TO: Mercedes-Benz Dealer Principals, General Managers, Sales Managers, Service Managers, Parts Managers	FROM: Thomas Brunner, Department Manager, Vehicle Compliance and Analysis, Engineering Services
RE: Recall Campaign 2017020016 Launch MY 2017 Model 166 (GLE-Class), 292 (GLE-Coupe), and X166(GLS) Rework the Center Console	DATE: February 24, 2017

RECALL CAMPAIGN LAUNCH NOTICE

Campaign No. :	Rework Center Console
2017020016	
This is to notify you of a new recall campaign with Retail Hold order for certain MY 17 GLE/GLE Coupe-Class (166/292) and GLS (X166) platform vehicles.	
Background	
Issue	This Recall Campaign has been initiated because Daimler AG ('DAG'), the manufacturer of Mercedes-Benz vehicles, has determined that on certain GLE/ GLS/ GLE Coupe vehicles (166/292 platform), the latch securing the center console doors might not meet the requirements of FMVSS 201 (Occupant Protection in Interior Impacts). Items secured in the center console might exit the compartment in the event of a crash, increasing the risk of occupant injury.
What We're Doing	MBUSA is launching a voluntary recall to rework the center console on affected vehicles.
Parts	No parts required. Work Instructio

Figure 1

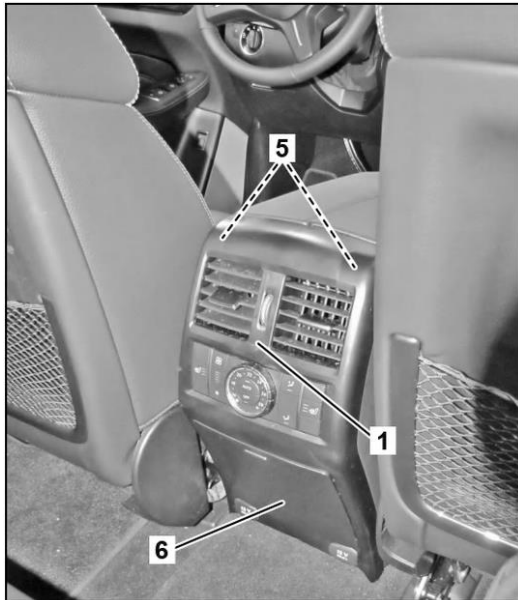
- There are two clips securing top (5) of rear panel (1) to the center console. To unclip rear panel (1), lift rear panel up then out from center console.
- Be sure to remove all rear panel (1) mounting screws before unclipping rear panel (1).
- Once rear panel (1) is unfastened from center console it can be folded back away from center console with interior harness attached.
